Access Compliance Report Public Rights-of-Way (Curb Ramps)

Main Street: PLEASANTON_LN Cross Street: CHANTILLY_LN Location: NE

ADA ID: RPRK211020153548 Ramp Type: Type 4 - Parallel Initial Pass/Fail: Fail Overall Compliance: No Severity Score: 15

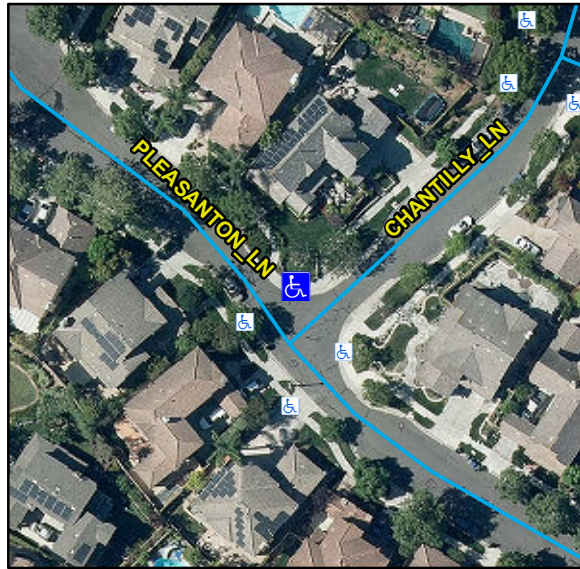
Compliance	Description	Data	Compliance	Description	Data
N/A	Ramp Length LT (in)	96	N/A	Ramp Length RT (in)	92
Yes	Ramp Width LT (in)	53	Yes	Ramp Width RT (in)	53
Yes	Ramp Run Slope LT (%)	5.8	No	Ramp Run Slope RT (%)	8.8
Yes	Ramp Cross Slope LT (%)	0.9	Yes	Ramp Cross Slope RT (%)	1.9
N/A	Landing Present	N/A	N/A	DWS Provided	N/A
N/A	Landing Length (in)	N/A	N/A	DWS Contrast	N/A
N/A	Landing Width (in)	N/A	N/A	DWS Length (in)	N/A
N/A	Landing Run Slope (%)	N/A	N/A	DWS Full Width	N/A
N/A	Landing Cross Slope (%)	N/A		DWS Offset Type	N/A
N/A	Landing Movement Obstructed?	N/A	N/A	DWS Offset Left (in)	N/A
	Landing Movement Type	N/A	N/A	DWS Offset Right (in)	N/A
N/A	Landing Shared	N/A			
N/A	Clear Space	Yes			
N/A	Clear Space To Crosswalk (in)	N/A			
N/A	Marked Crosswalk 1	No	N/A	Marked Crosswalk 2	No
	Crossing 1 Direction	W		Crossing 2 Direction	S
	Marked Crosswalk 1 Width (in)	N/A		Marked Crosswalk 2 Width (in)	N/A

Remove & Replace Curb Ramp With Two New Directional Ramps or Equivalent.

R204.3, R304.3.2, STD 1115
